E/ECE/324 }
E/ECE/TRANS/505 } Rev.1/Add.20/Rev.2/Amend.2

Addendum 20: Regulation No. 21

Revision 2 - Amendment 2

UNIFORM PROVISIONS CONCERNING THE APPROVAL OF VEHICLES WITH REGARD TO THEIR INTERIOR FITTINGS

FIGURE 1

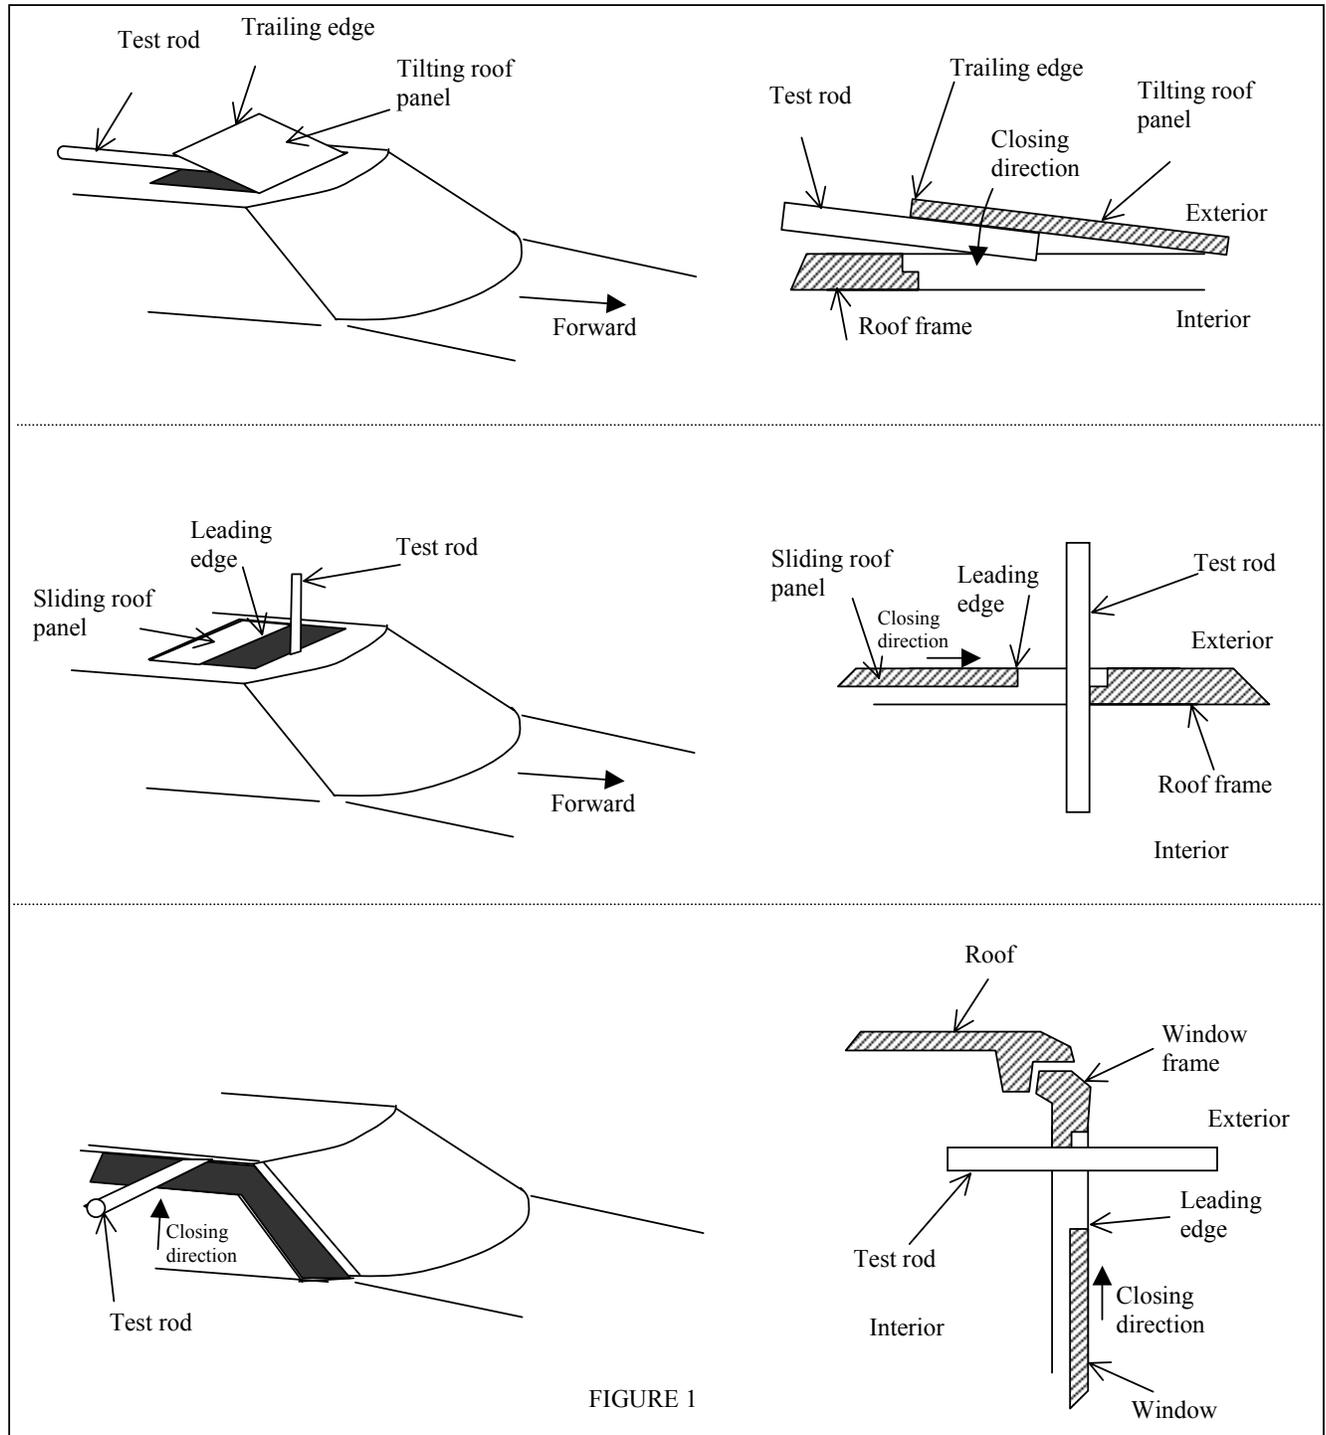
(normally located perpendicular to the edge of the window/roof panel/partition and perpendicular to the closing direction) are illustrated in Figure 1 of annex 9 to this Regulation. The position of the test rod relative to the edge and the closing direction shall be kept throughout the test.

FIGURE 2

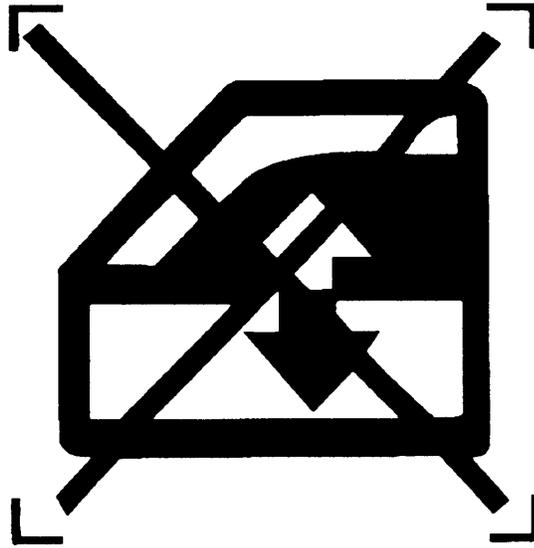
The driver-controlled switch shall be located so as to minimize any accidental manipulating. It shall be identified by the symbol shown in Figure 2 of annex 9 to this Regulation or an equivalent symbol, for example according to ISO 2575:1998 reproduced in figure 3 of annex 9 to this Regulation.
